**FURTHER OBJECTION TO DEVELOPMENT PROPOSALS MP\_07 0166 MOD 8**

MP07\_0166 Mod 8 is an application seeking to modify the Wahroonga Estate Concept Plan by providing detailed amended residential building envelopes and amended residential car parking rates for Precinct B: Central Church Precinct. The modification does not seek to alter the total maximum dwellings approved under the existing Concept Plan.

indicative solar access diagram

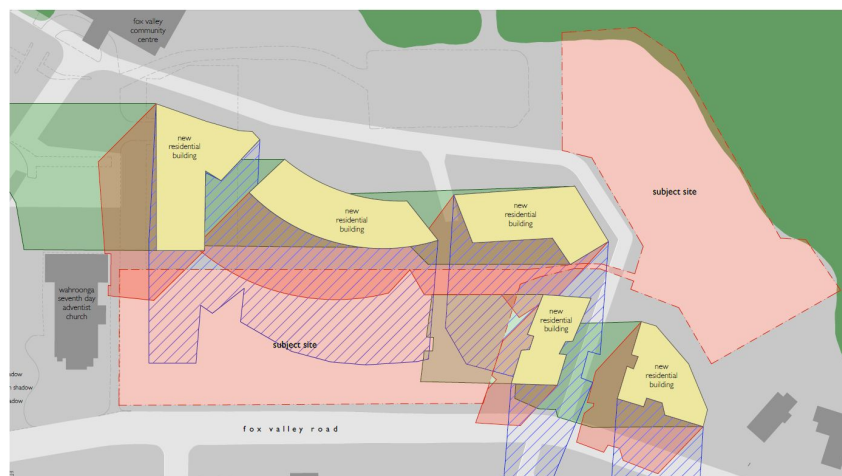
*The location of the main campus facilities on School Lot 1 will be adjoining future residential development to the north and north-west. With the permissible height limit of these residential sites being 20.5m, the new school will potentially be impacted by overshadowing from future buildings along the north-western edge of the site.*

Whilst the amended plans, have amended the location of the building envelopes slightly, it can be seen from the above diagram that a large proportion of the school site will remain in shadow. Accordingly, it is considered that the concerns remain valid and the proposal will result in negative adverse impacts on the adjacent school site. The proposed Mod 8 application to increase the height planes and height limits of the buildings should not be approved and the detailed floor plans should also not be approved for the above reasons.
